U.S. NUCLEAR REGULATORY COMMISSION
OFFICE OF INSPECTION AND ENFORCEMENT

Report No. 50-368/81-17

Facility Name: Arkansas Nuclear One - Unit 2

Areas Inspected: Special, announced inspection of both the "A" and "B" reactor coolant pump welds and the snubber lug on steam generator 2, the safe end welds on the "B" reactor coolant pump, and the fabrication radiographs for all four reactor coolant pump safe end welds.

FIGURE 2

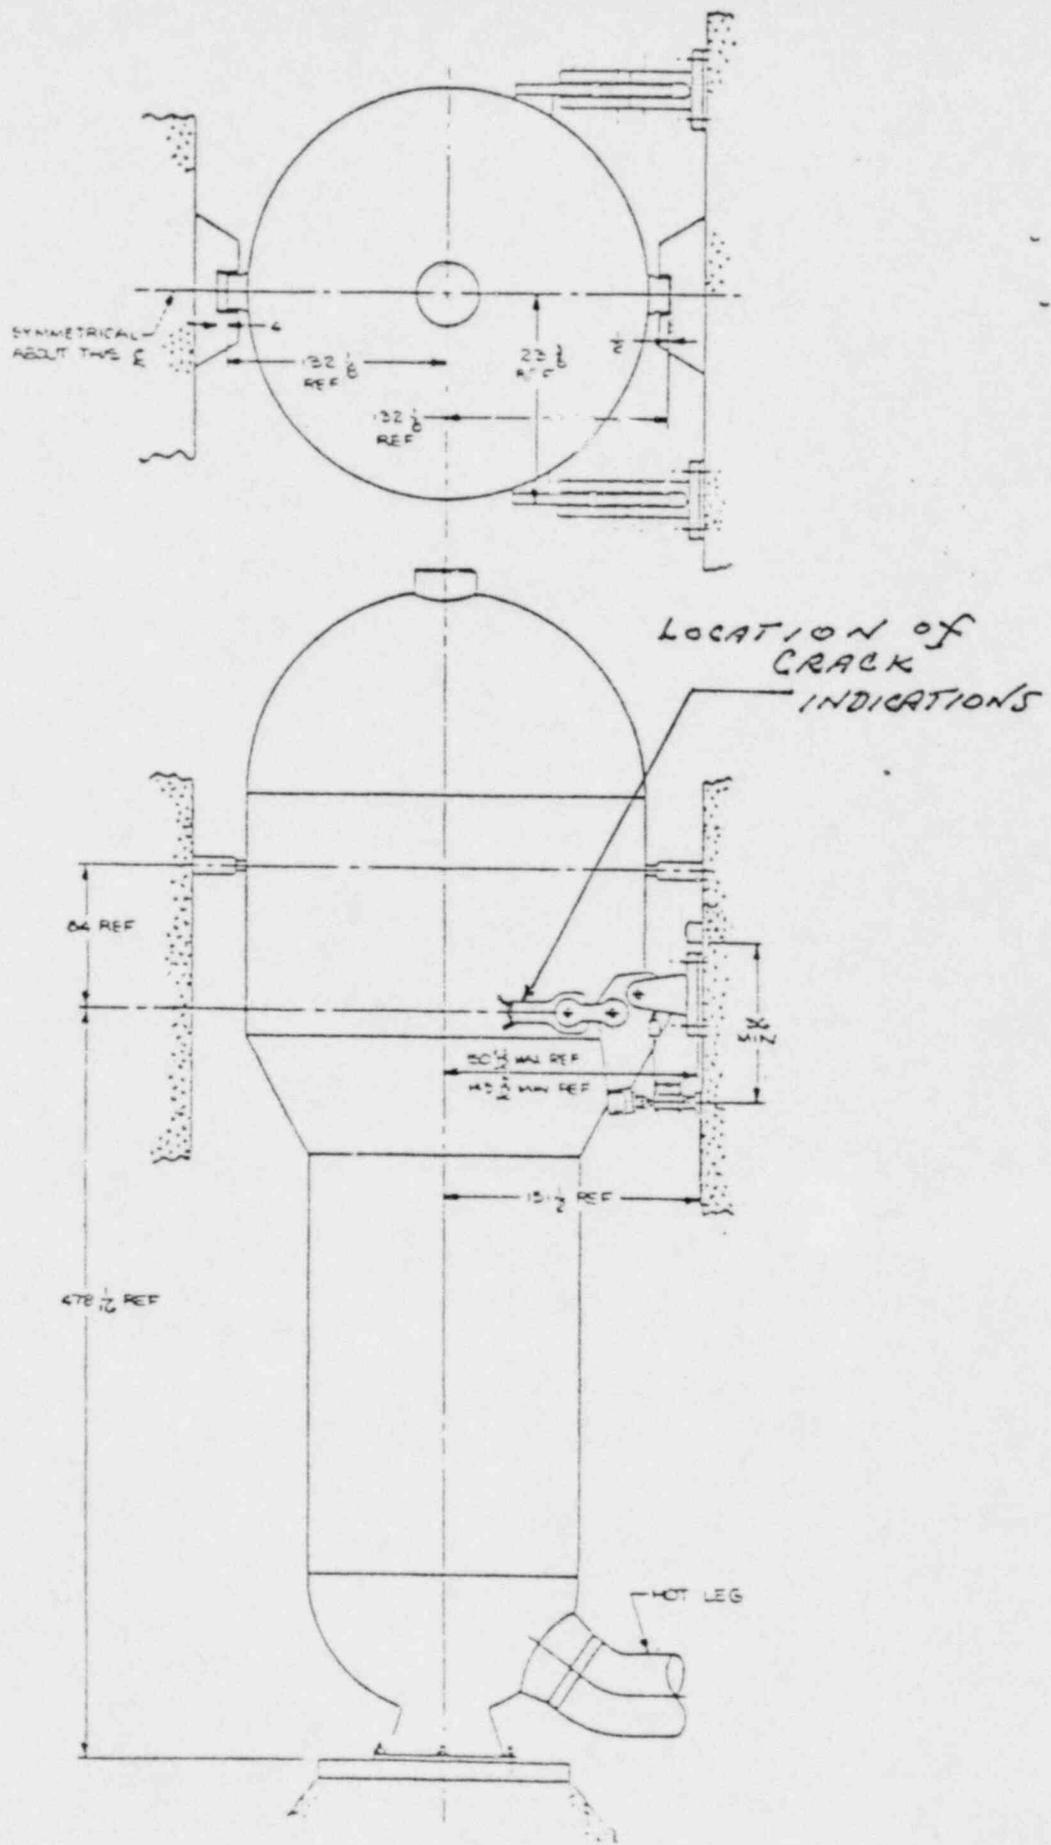
Following the above discussion AP&L further informed the staff that a LPT examination had also disclosed crack indications in an upper-side weld of a snubber lug forming an intergrally welded support to steam generator 2,

as shown in Figure 2. These indications were intermittently disposed linearly, ranging from 1/6" to 3/16" in length, along the edge of the weld to the vessel. At this time AP&L indicated a relief request would be submitted to change from a portion of the presently applicable ASME Section XI ISI Code (1974 Edition and Summer 1975 Addenda) to the later approved 1977 Edition and Addenda of the Code. Specifically, to permit use of the more definitive ISI acceptance criteria of the latter, as it relates to intergrally welded supports in evaluation of the snubber lug indications. On May 13, 1981 AP&L submitted their formal request for relief on this matter for staff consideration.

Upon completion of the above investigation, a close visual examination (optically aided) of the reported snubber lug crack indications was made by the inspector. It was determined these indications were in fact due to (1) Partial weld bead foldover in making the final weld pass at the vessel shell and (2) shallow fusion craters in weld bead start and stop points, that were not entirely removed following welding of the lug to vessel shell.

6. An investigation of the snubber lug welds also showed the reported "crack indications" were of similar characteristics as the pump welds; engendered by the welding process during installation on the vessel. These were removed by blend grinding and PT cleared.

All linear indications on the "A" and "B" RCP safe end welds and snubber lug were effectively removed by the modified grinding techniques. The existing cavities on the "A" pump welds were blended to surrounding surfaces to eliminate stress concentration effects. The depth of grinding for removal of indications was minimal (cosmetic) and did not violate the design minimum wall thickness. The entire welds were PT examined following repairs and found acceptable. A photographic record was made of the "B" pump welds and snubber lug conditions and of the repairs as required.
